**Public Hearing for Rotella's Italian Bakery
Planned Unit Development (PUD)**

RECOMMENDATION REPORT

CASE NUMBER: PPUD-17-0008

RE: Rotella's Italian Bakery
Site Development Plan
Proposed Planned Unit Development (PUD) Site Plan - Initial Review

FIRE HYDRANT LOCATION PLAN EXISTING & NEW LIGHT POLES

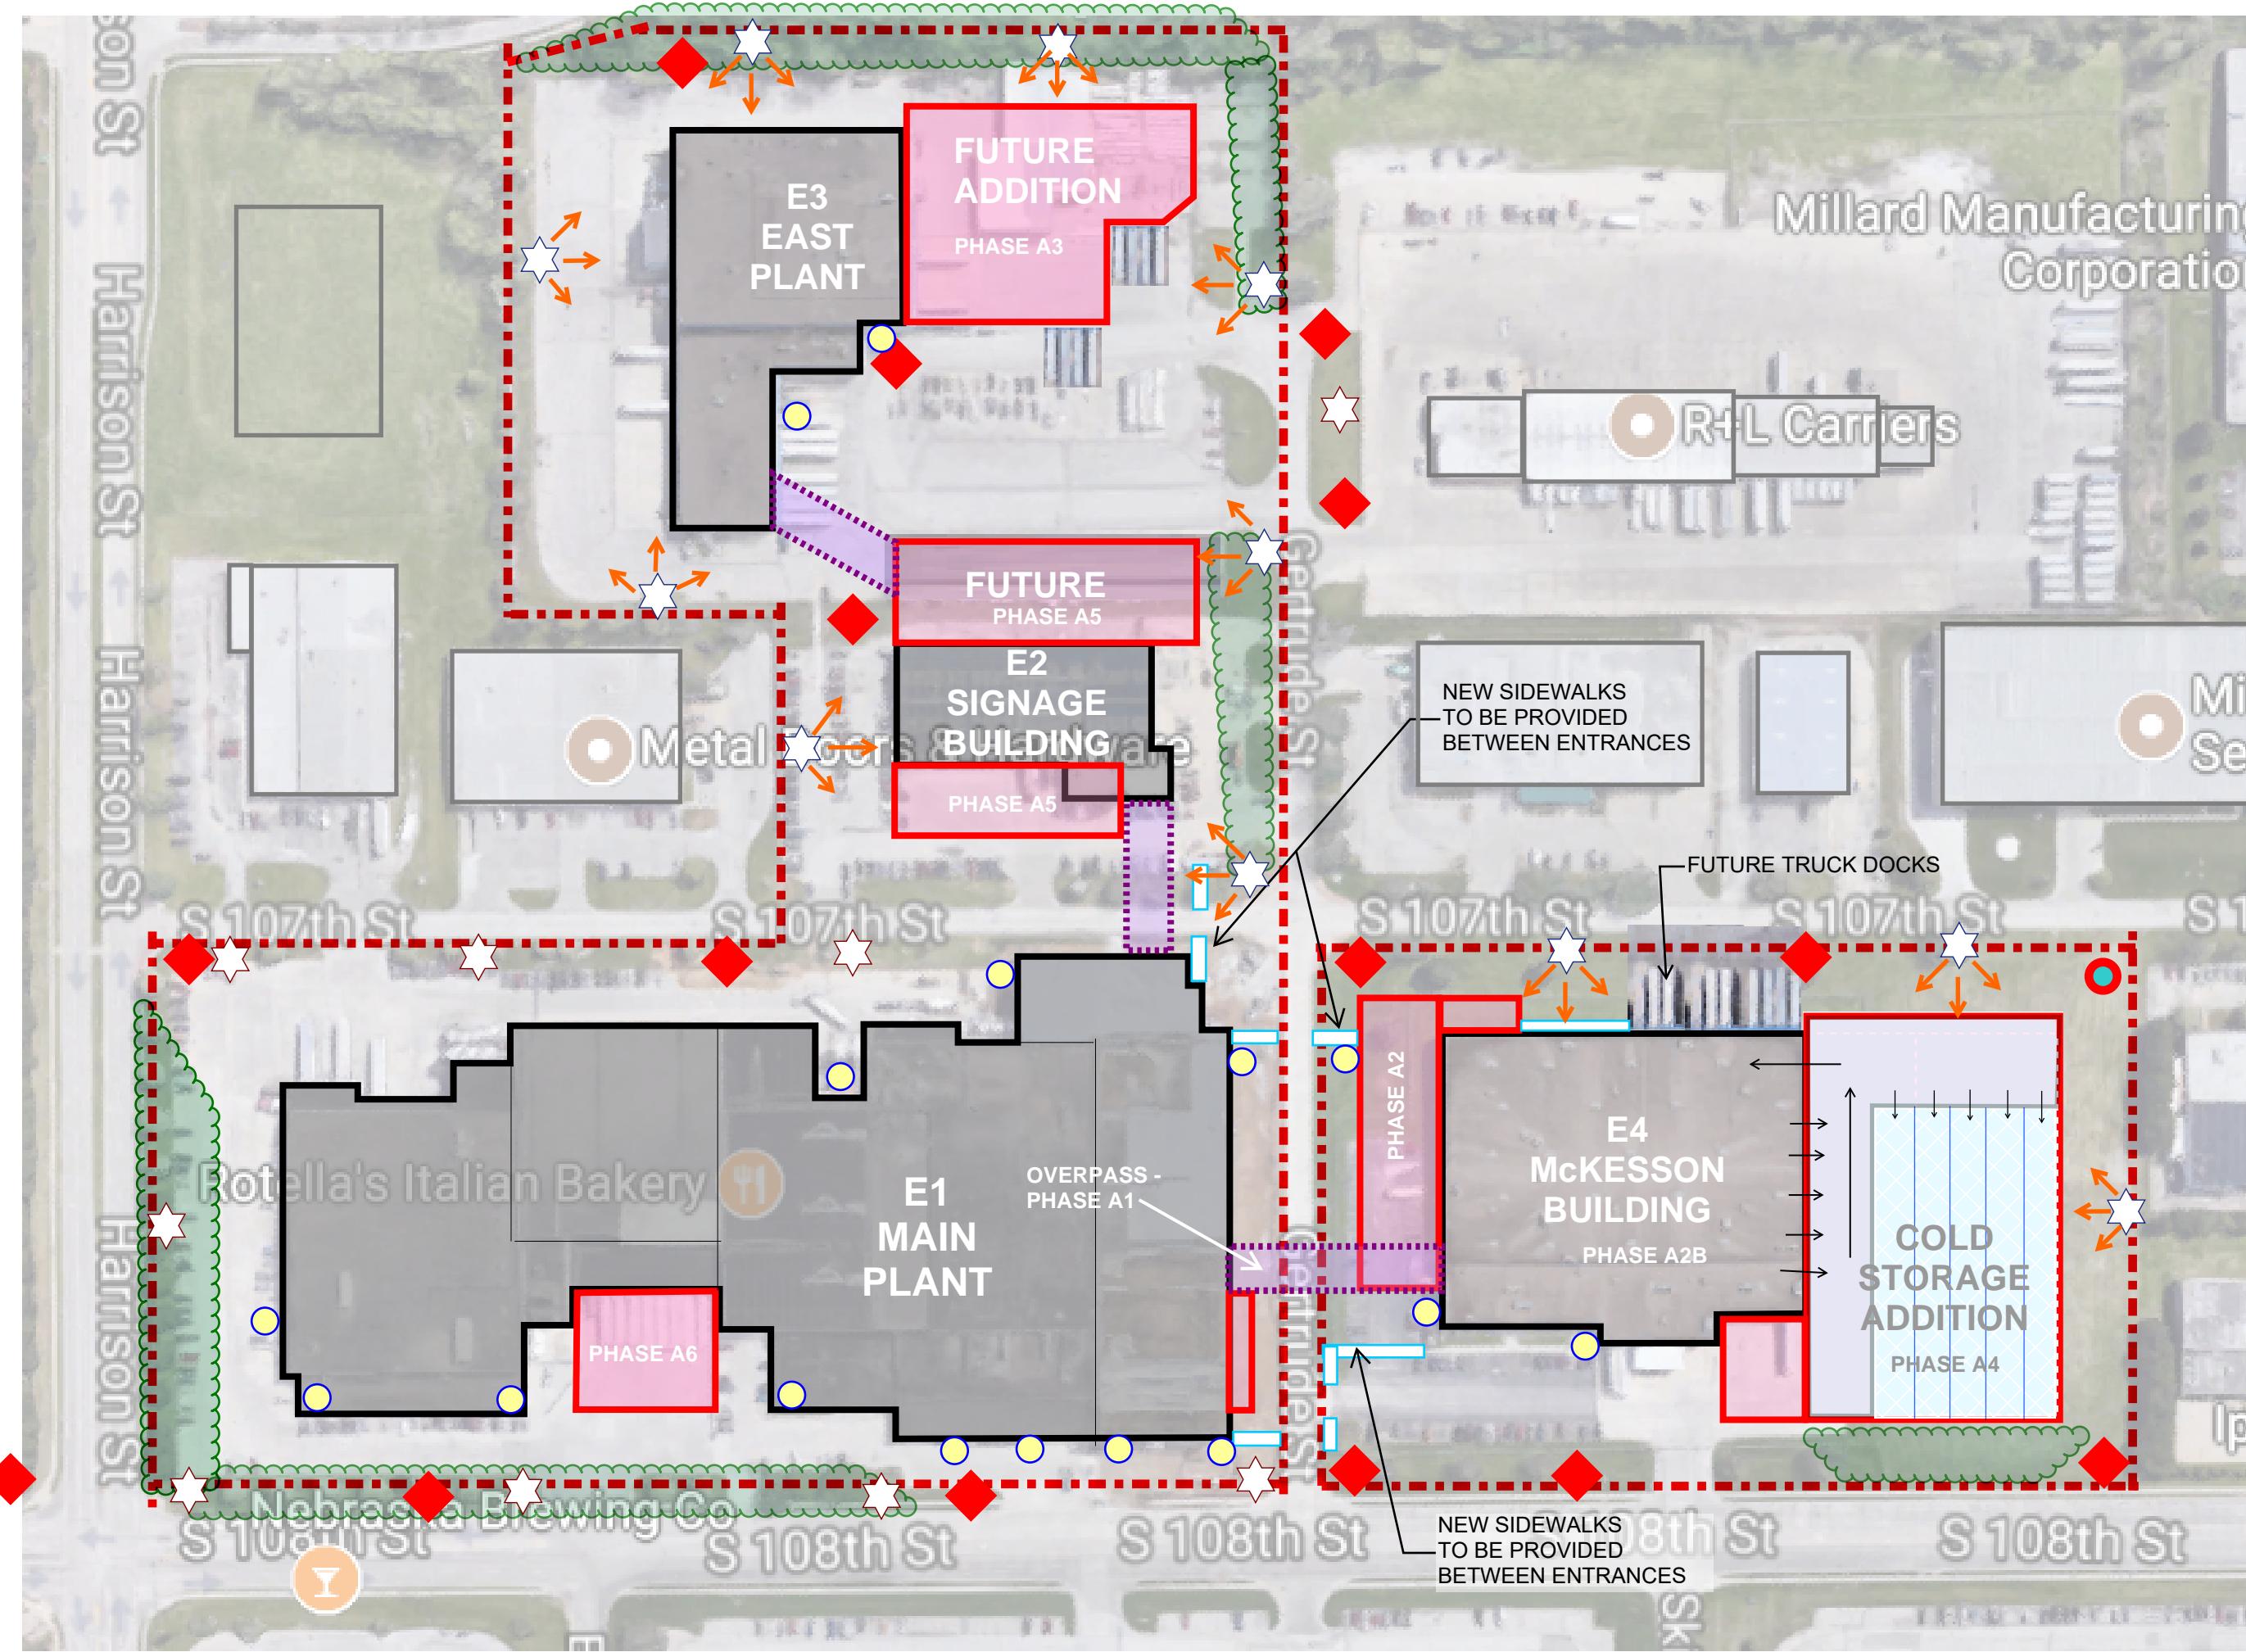
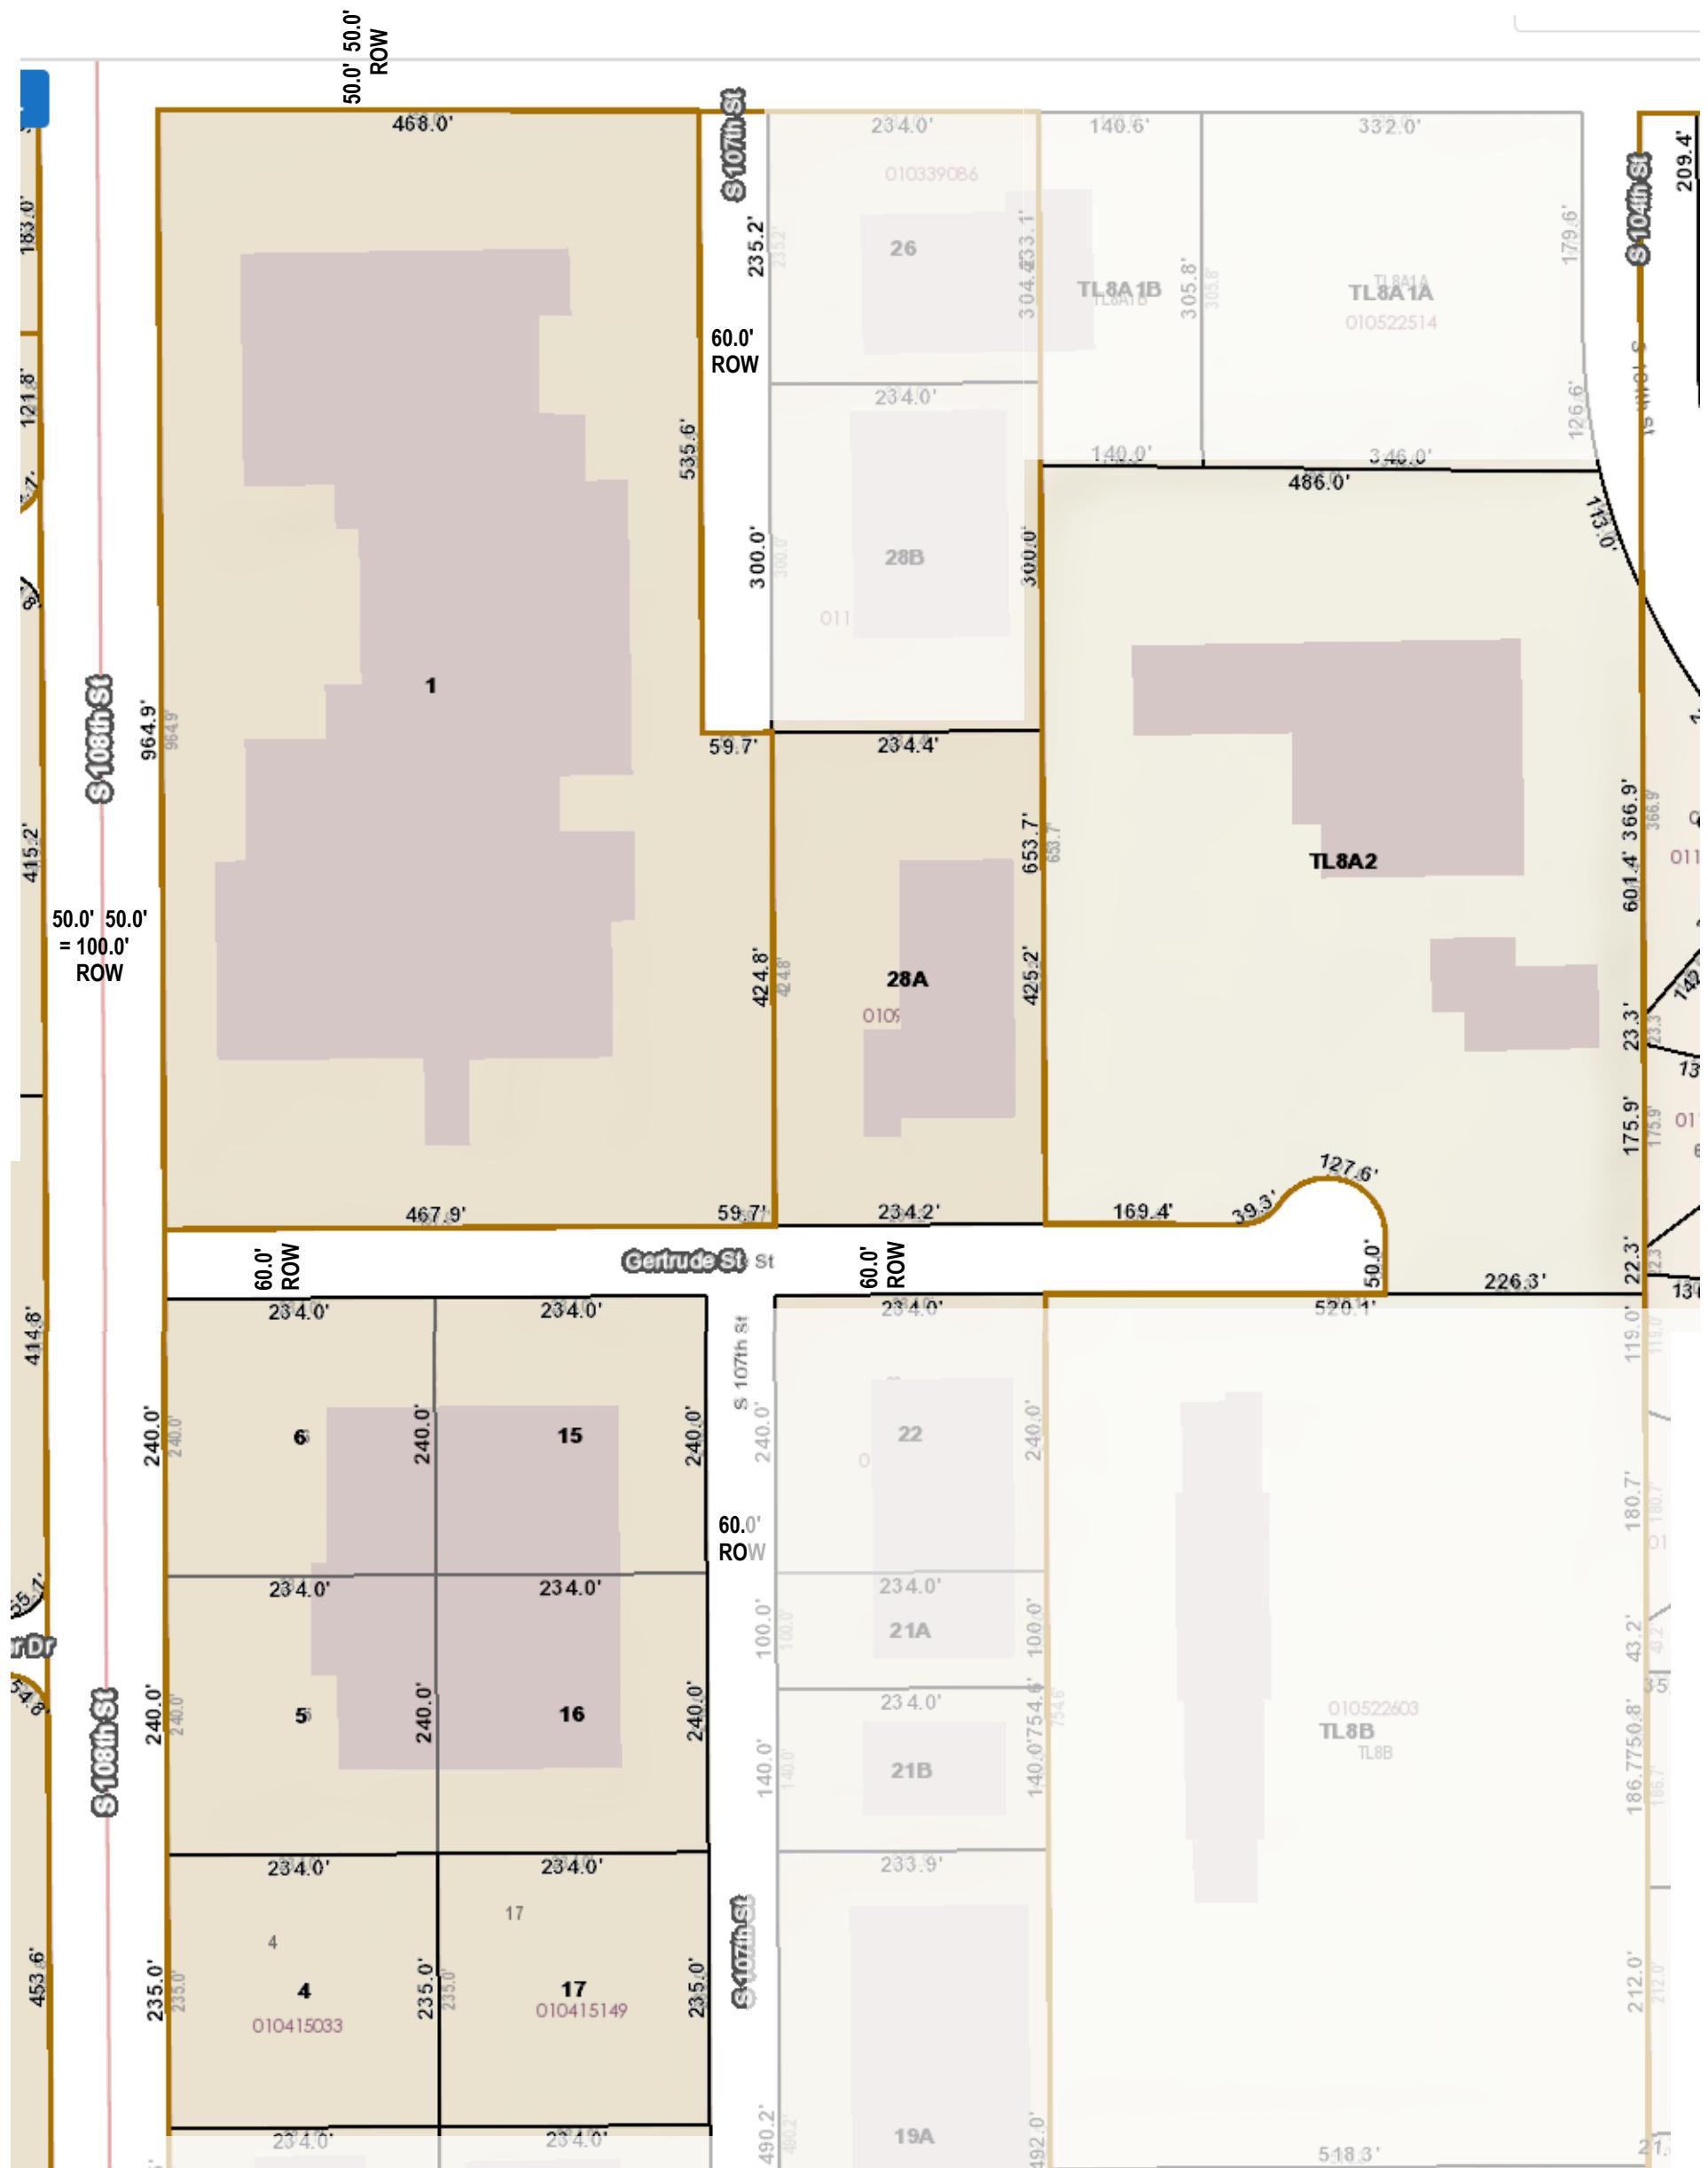
a. Comment: Photometric studies will be required for building modifications on lots abutting residential properties.

- Comment:** Additional information needs to be provided about proposed lighting near the eastern edge of the PUD.
- Response:** We agree that having light spill over onto the adjoining properties is not desirable. Our electrical engineer has recommended that the **attached fixture data sheet** be specified as a basis of design for those areas that are sensitive to light spillage. The recommended fixture has excellent cut-off properties and can also be fitted with a light shield to further control the direction of light from the fixture.

b. Response: Site lighting will be located so that it shines toward the building and not onto adjacent properties. Proposed locations for site lighting is shown on the site utilities plan.
Building shadows: The tree line along the east property line (adjacent to the residential area) is taller than the addition A3 that is planned for the east plant. A 3D study can be provided during the design of future buildings to show the path of shadows relative to adjoining sites.

FUTURE TRAFFIC DIAGRAM & PARKING

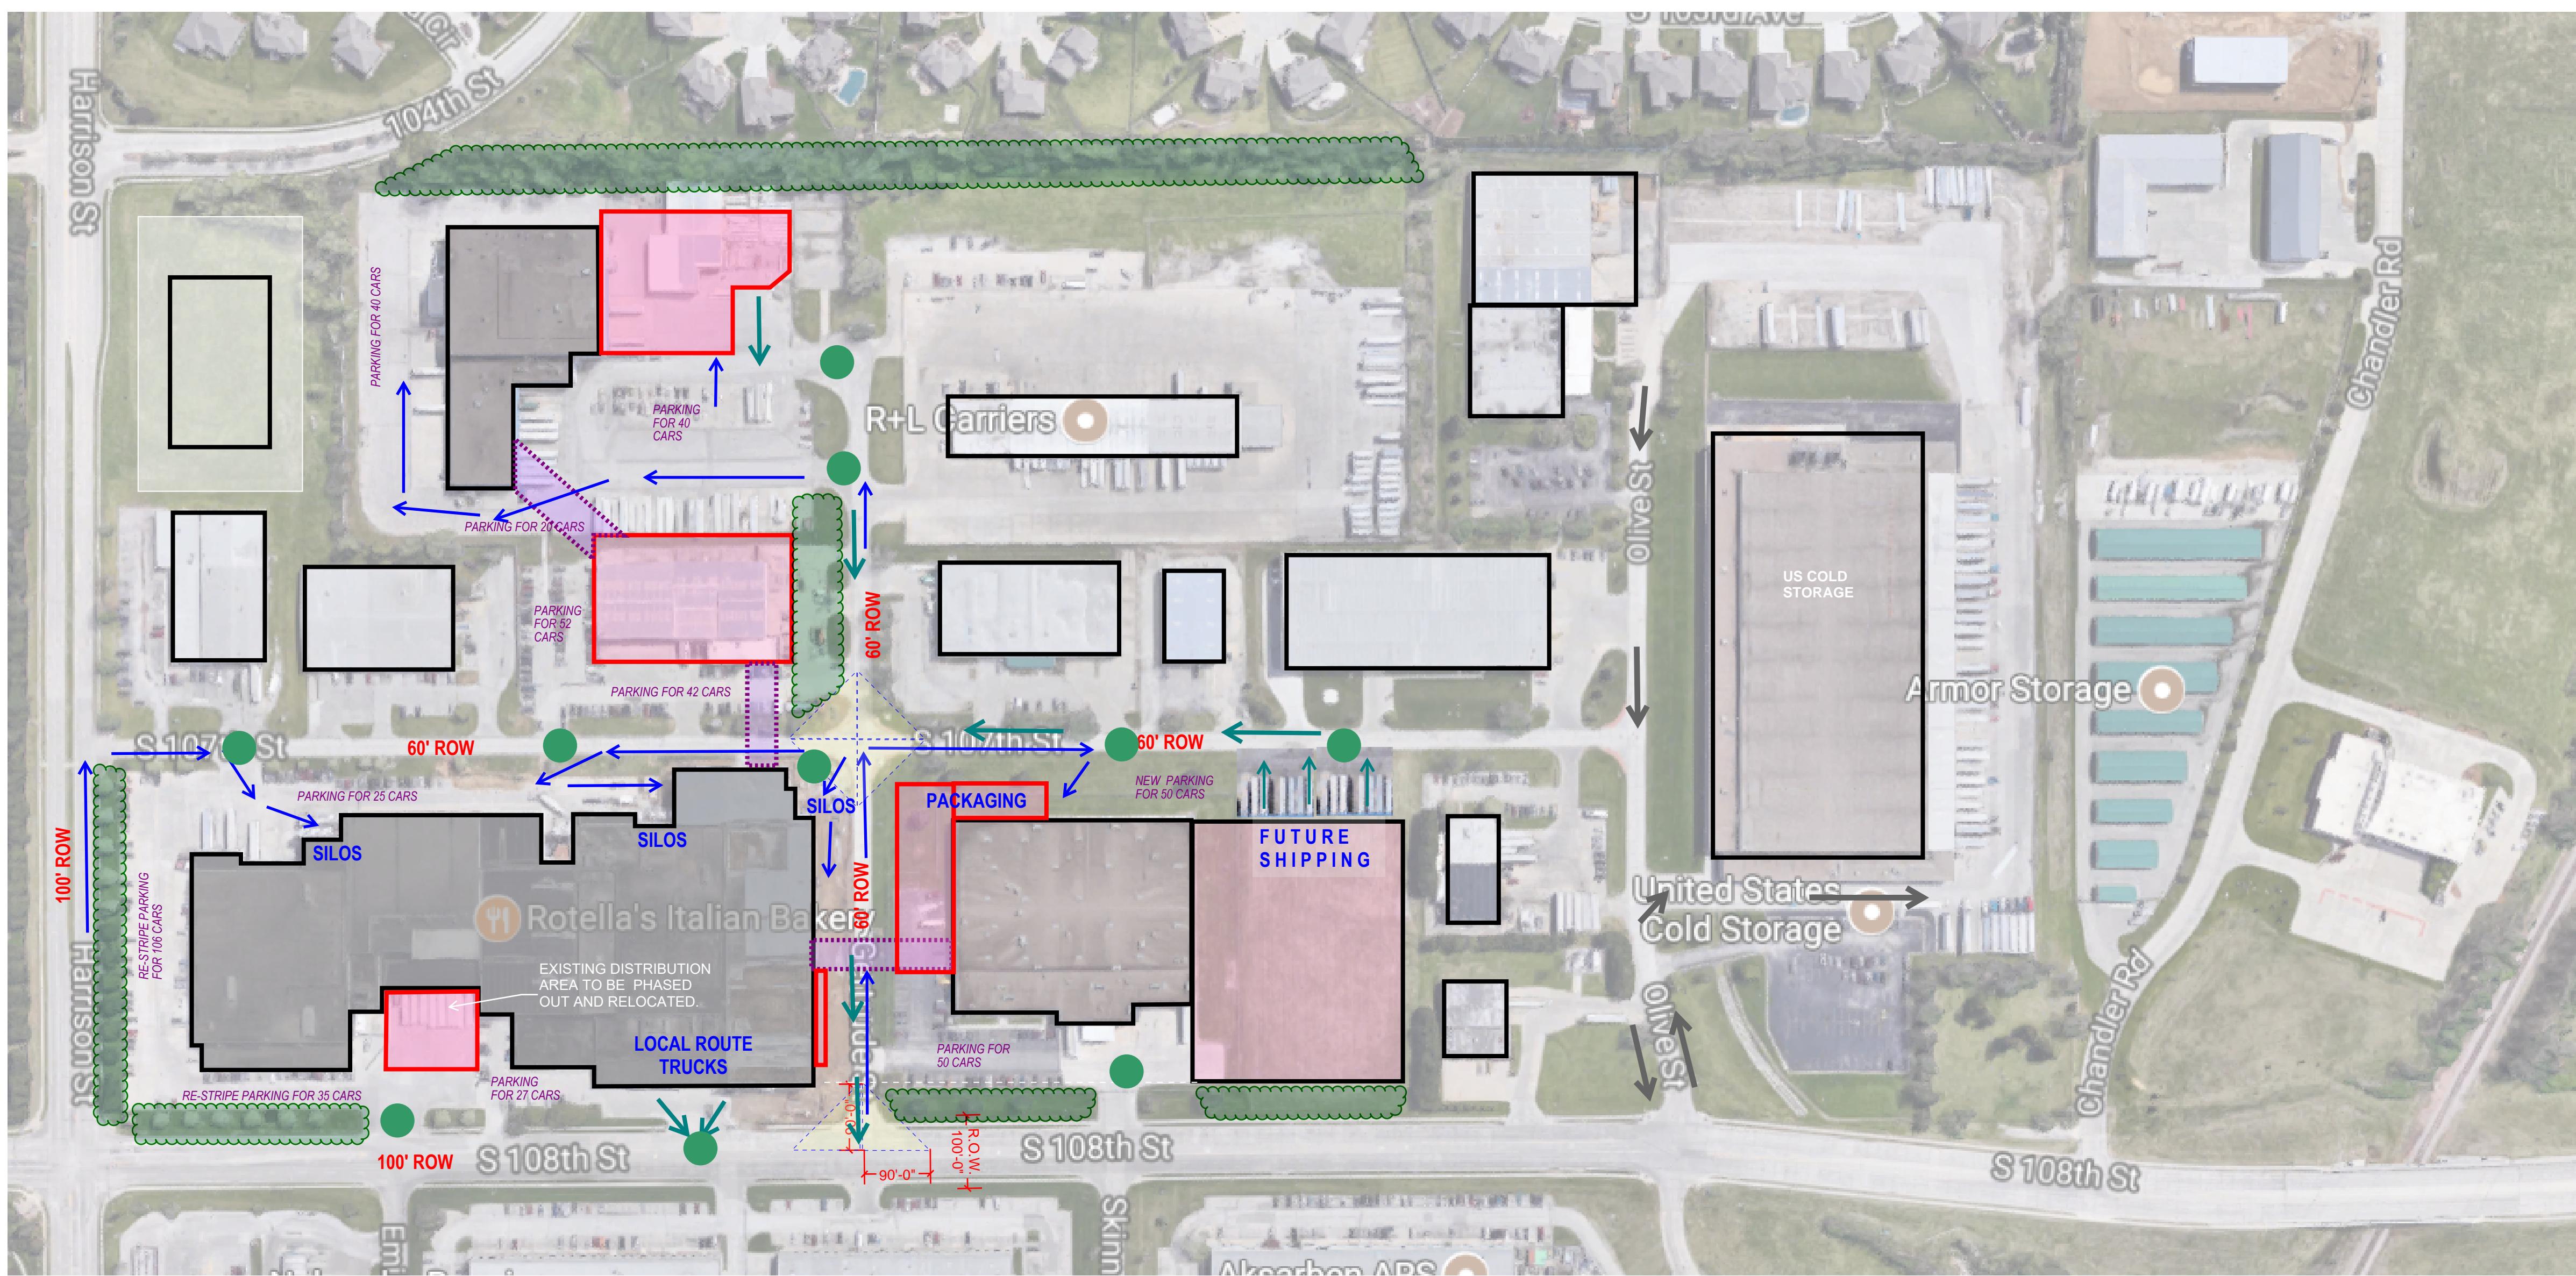
1. On Attachment 4a-Future Traffic Diagram, it indicates that the estimated average daily long-distance, outbound trucks will be 70 per day in lieu of the current 60 trucks per day leaving the U.S. Cold Storage Facility. On the assumption that U.S. Cold Storage will replace the lost business with other customers, there could be an increase of 70 trucks per day entering onto 108th Street. The applicant should identify how many of the 70 trucks might occur during peak hour.

- 1) Item 1 -
 - a. Regarding **Table 3D – Future Truck Traffic**:
 - i) **Comment:** On the assumption that US Cold Storage will replace the lost business with other customers there could be a net increase of 70 trucks per day entering 108th street. Also, identify how many of the 70 trucks might occur during peak hours.

- ii) **Response:**
 - (1) The Rotella automated cold storage facility would operate 24/7, and would be designed for future outbound traffic of 70 trucks per day. These would be distributed throughout the day. The estimated traffic load is 3 trucks per hour average, with a peak of 6 per hour. The calculation is based on the following assumptions:

(3) See revised **Table 3D** for traffic volume recap, and the revised **Future Traffic Diagram** has been added.
